DANE COUNTY DEPT. OF PUBLIC WORKS, HIGHWAY & TRANSPORTATION

ADDENDUM

RFB NO. 320038 - ADDENDUM NO. 02

DANE COUNTY SHERIFF'S SE PRECINCT REMODEL AND ADDITION

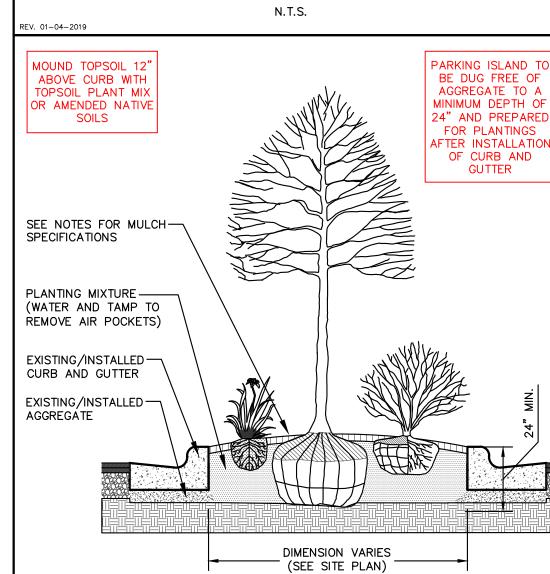
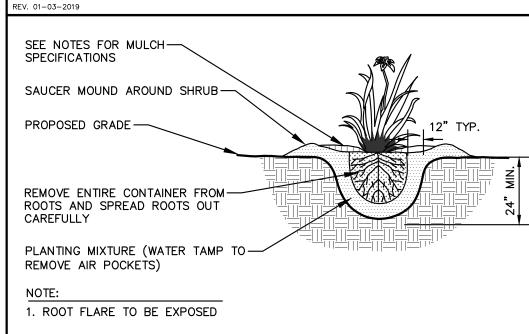
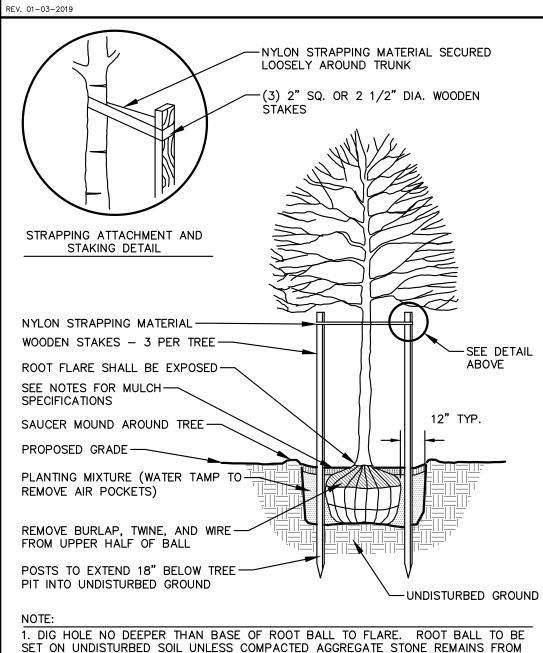
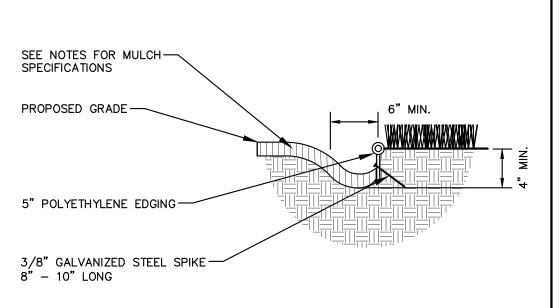
18. Sheet L2.0

Modify current Sheet L2.0 Landscape Details and Ntoes as indicated and issued with this Addendum.

AD101

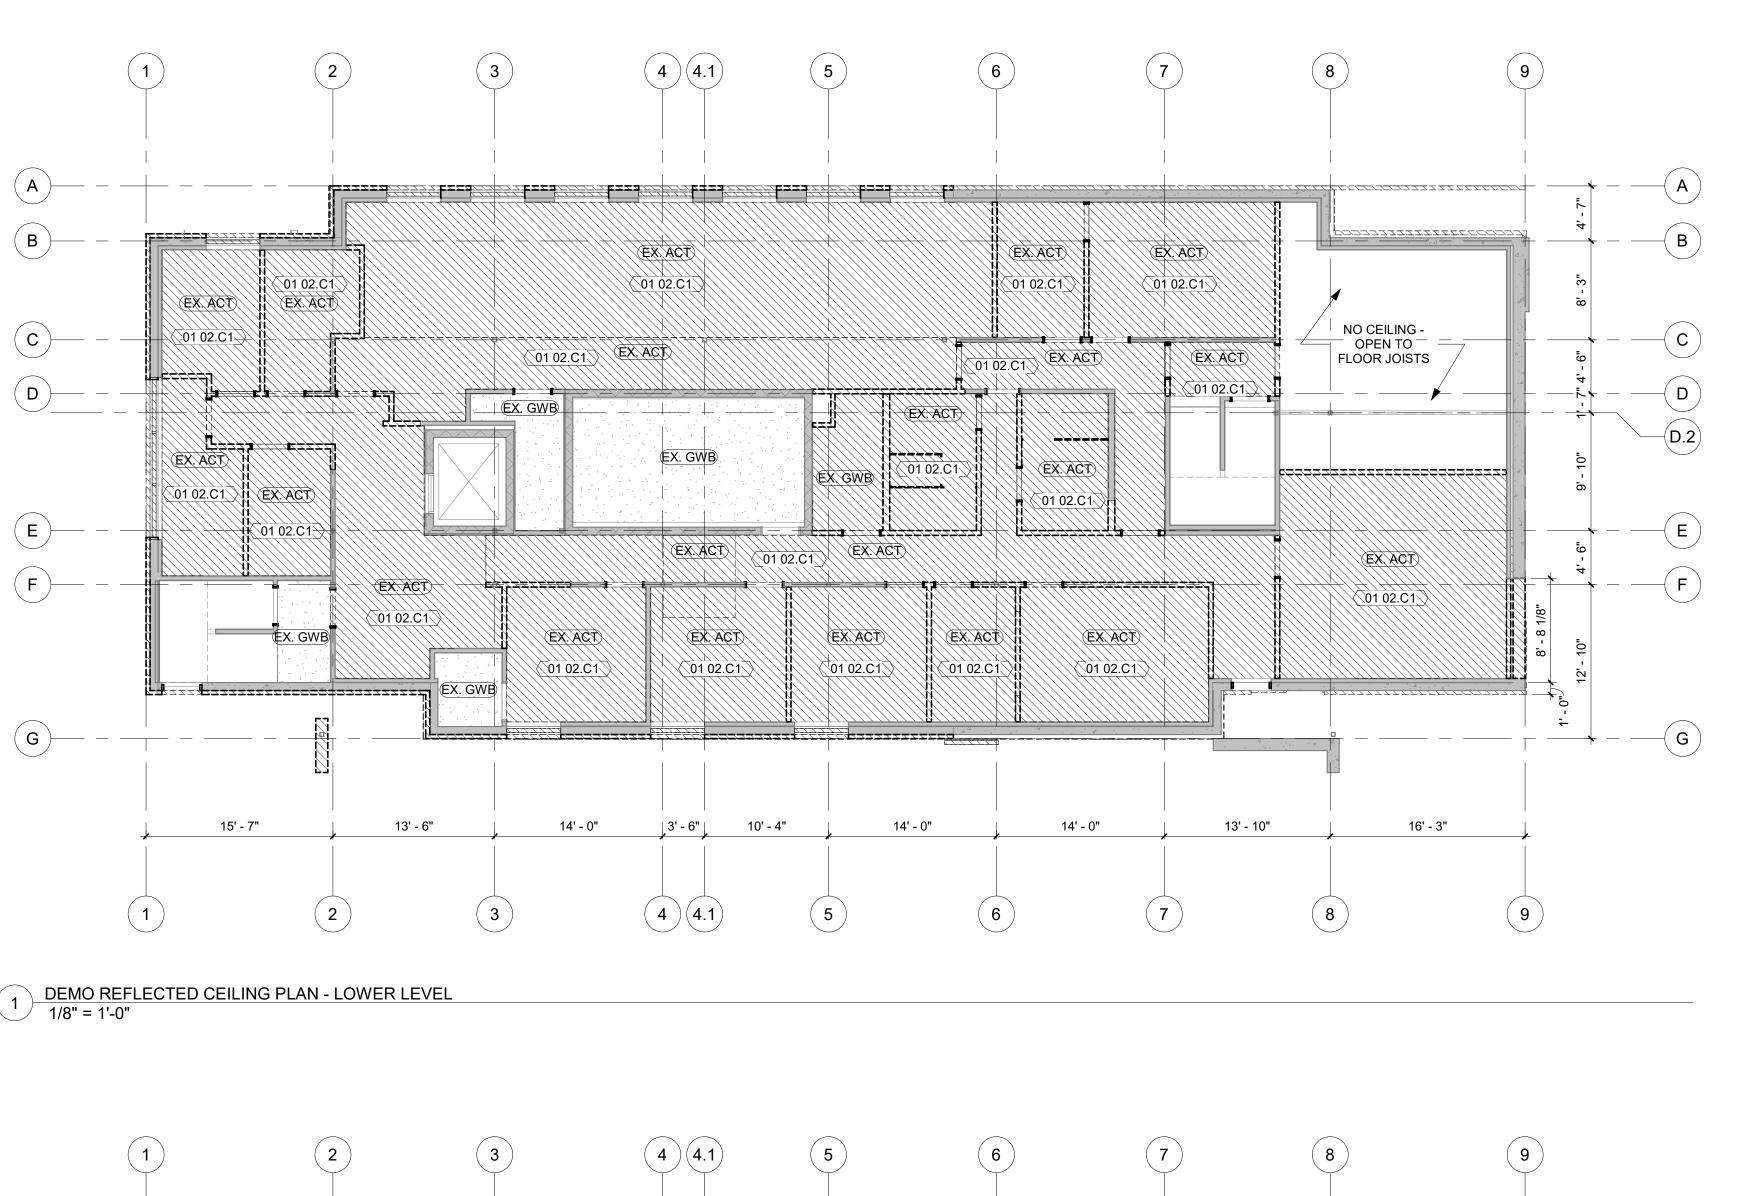
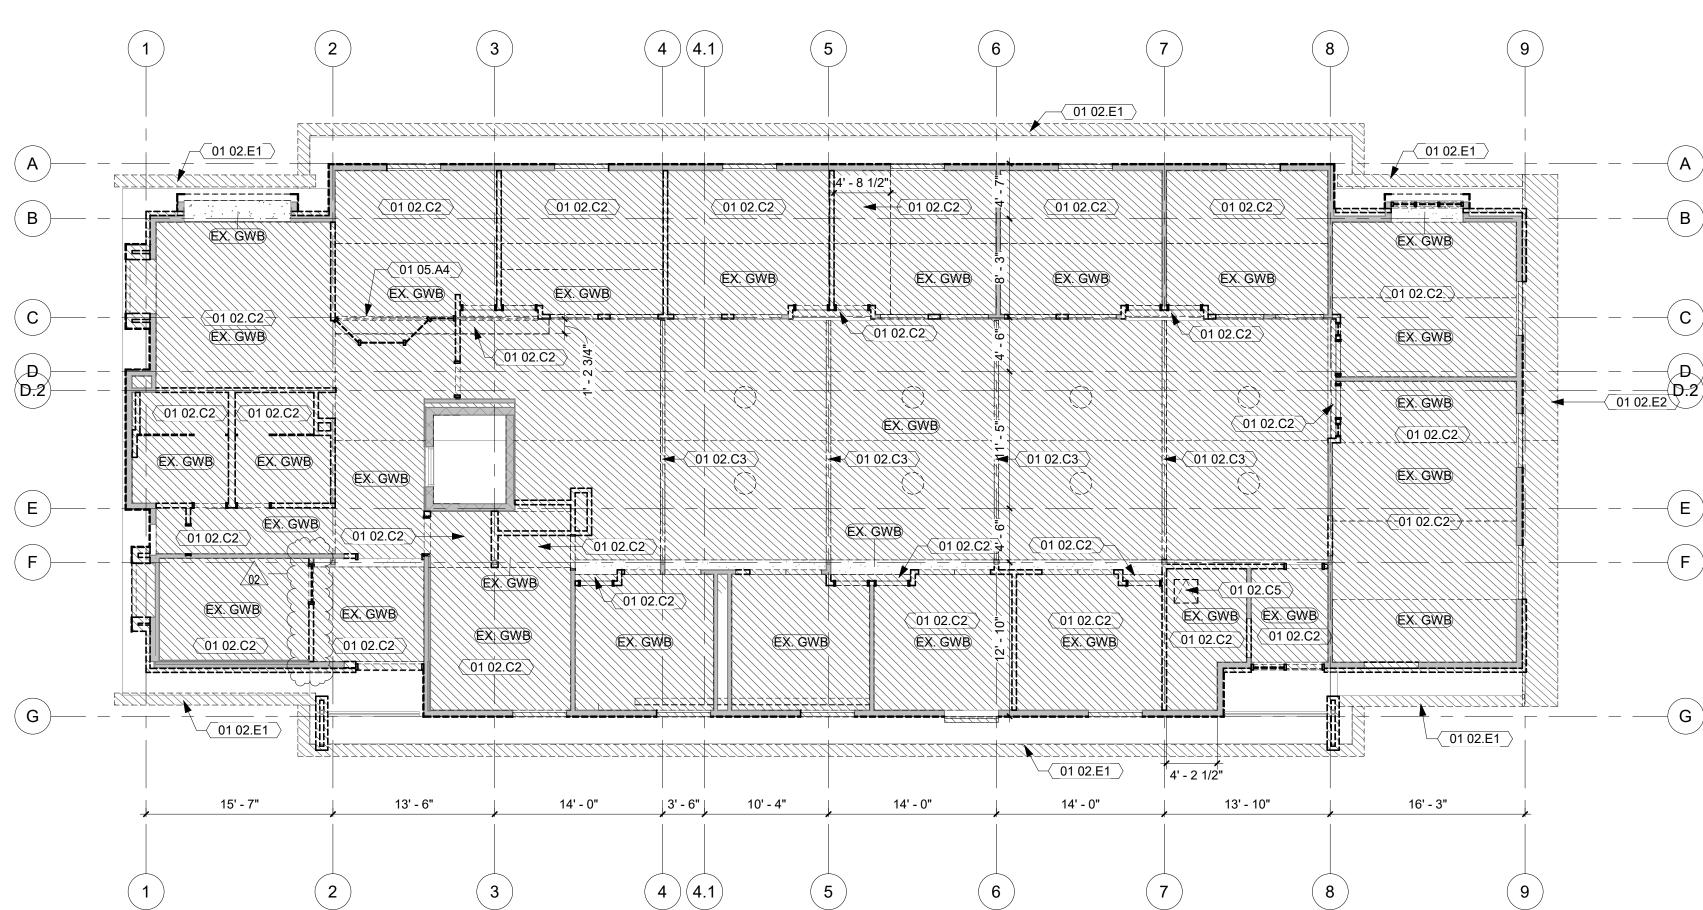
19. Sheet AD101

Modify current Sheet AD101 Demolition Plans as indicated and issued with this Addendum.

20. Sheet AD701

Modify current Sheet AD701 Demolition Reflected Ceiling Plans as indicated and issued with this Addendum.

A301

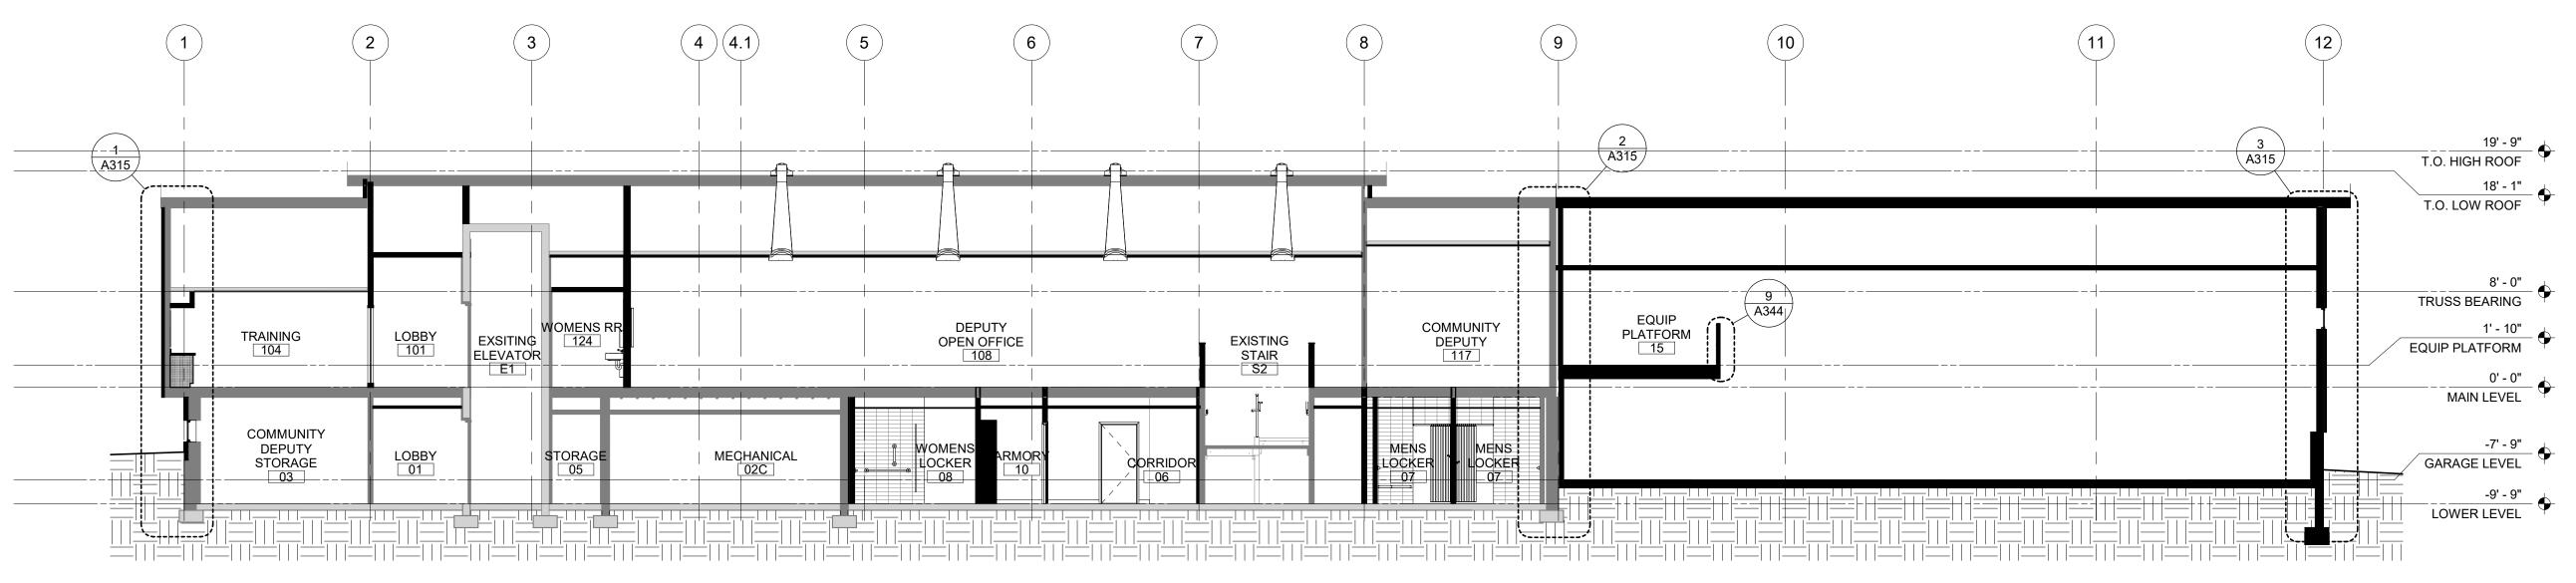
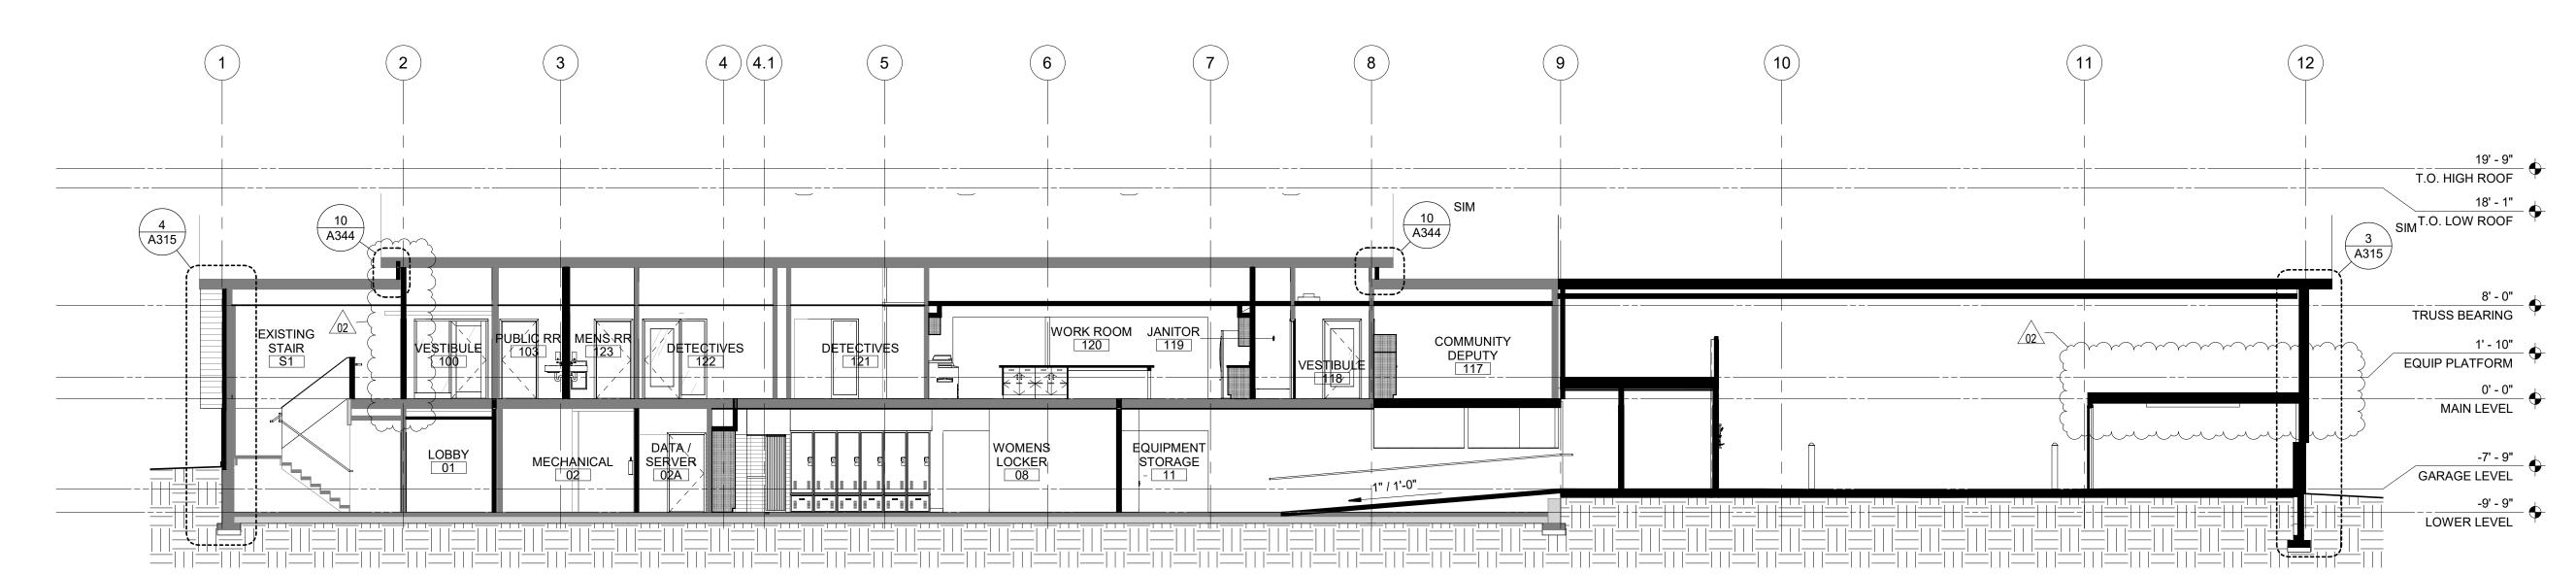
27. Sheet A301

Modify current Sheet A301 Building Sections as indicated and issued with this Addendum.
